Errata Sheet V1.0

- The following datasheets:
 - AT91M40800 Summary, Rev. 1348CS–05/00
 - AT91X40 Series, Rev. 1354C–08/01
 - AT91M40800 Electrical Characteristics, Rev. 1393A–08/00
- 100-lead TQFP devices with the following markings

**AT91M40800
Errata Sheet
V1.0**

Figure 1. NWAIT Rising

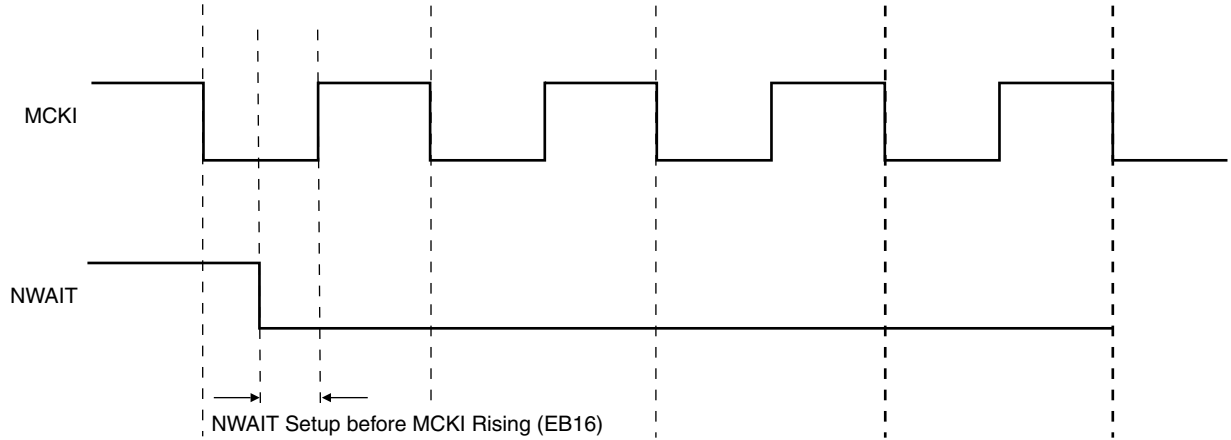
If the NWAIT setup time is satisfied on the first rising edge of MCKI, the behavior is accurate. The EBI operations are not affected when the NWAIT rises.

Figure 2. Number of Standard Wait States is Two

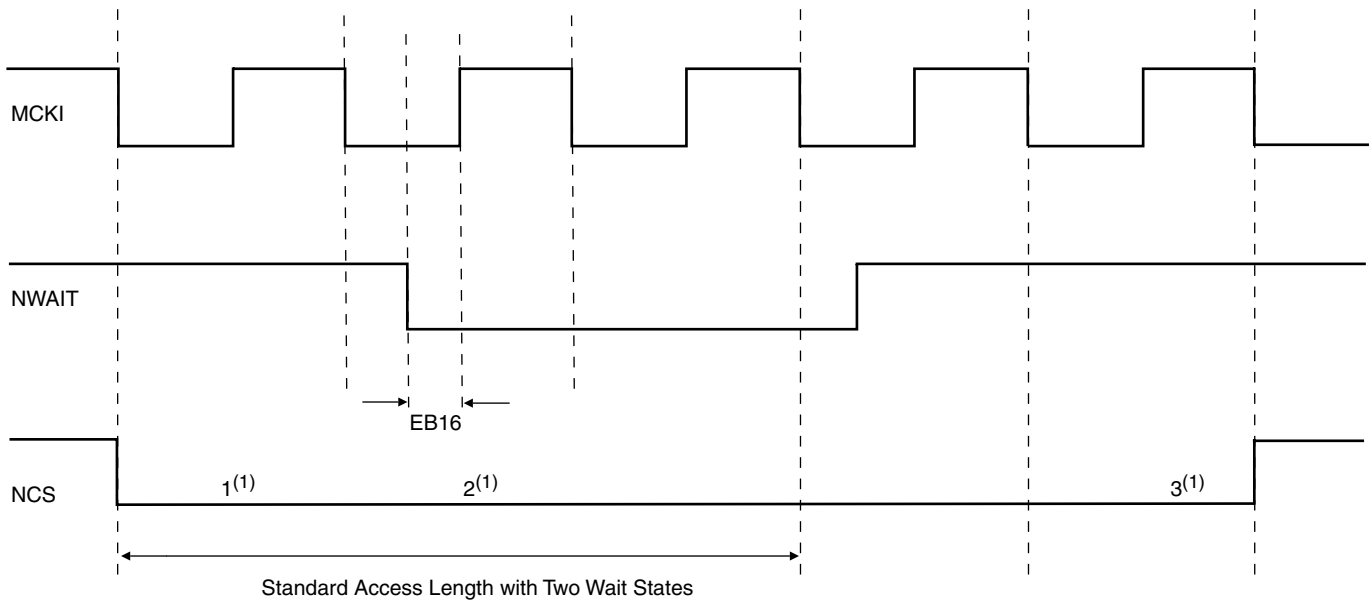
If the NWAIT setup time is satisfied on the following edges of MCKI and if at least one standard wait state remains to be executed, the behavior is accurate. In the following example, the number of standard wait states is two. The NWAIT setup time on the second rising edge of MCKI must be met.

Figure 3. Number of Standard Wait States is One

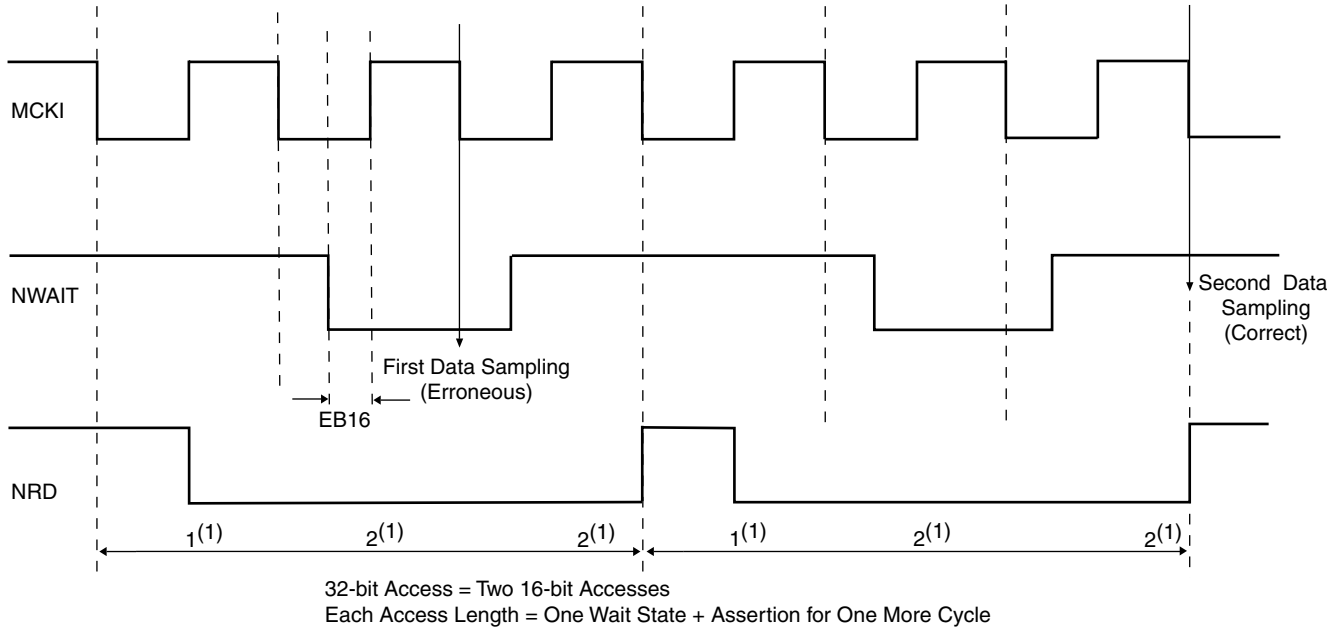
If the first two conditions are not met during a 32-bit read access, the first 16-bit data is read at the end of the standard 16-bit read access. In the following example, the number of standard waits is one. NWAIT assertions do affect both NRD pulse lengths, but first data sampling is not delayed. The second data sampling is correct.

At maximum speed, asserting the NWAIT in the first access cycle is not possible, as the sum of the timings “MCKI Falling to Chip Selec” and “NWAIT setup to MCKI rising” are generally higher than one half of a clock period. This leads to using at least one standard wait state. However, this is not sufficient except to perform byte or half-word read accesses. Word and write accesses require at least two standard wait states.

Figure 4. Description of the Number of Standard Wait States

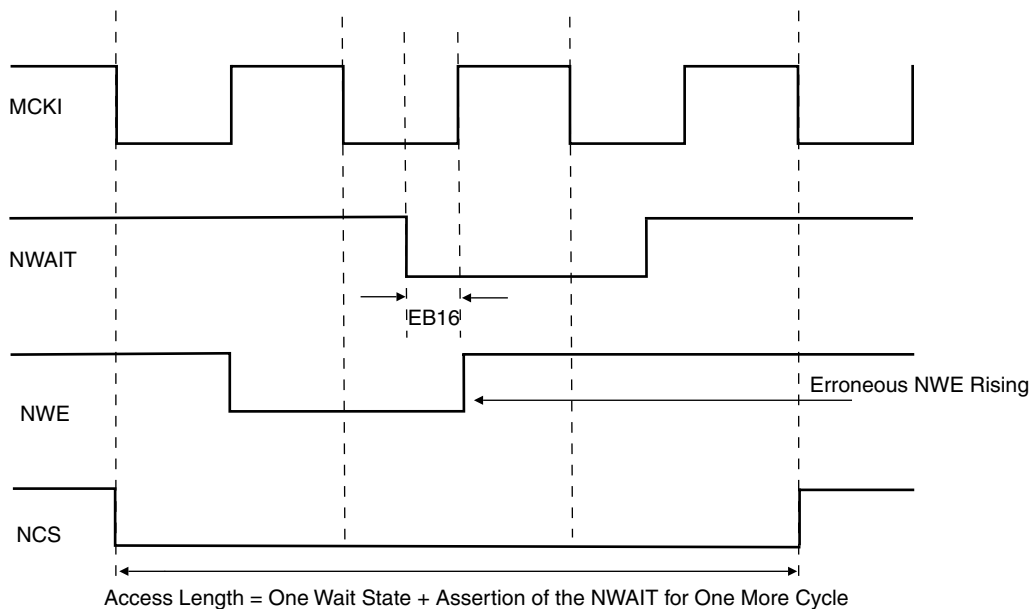
If the first two conditions are not met during write accesses, the NWE signal is not affected by the NWAIT assertion. The following example illustrates the number of standard wait states. NWAIT is not asserted during the first cycle, but is asserted at the second and last cycle of the standard access. The access is correctly delayed as the NCS line rises accordingly to the NWAIT assertion. However, the NWE signal waveform is unchanged, and rises too early.
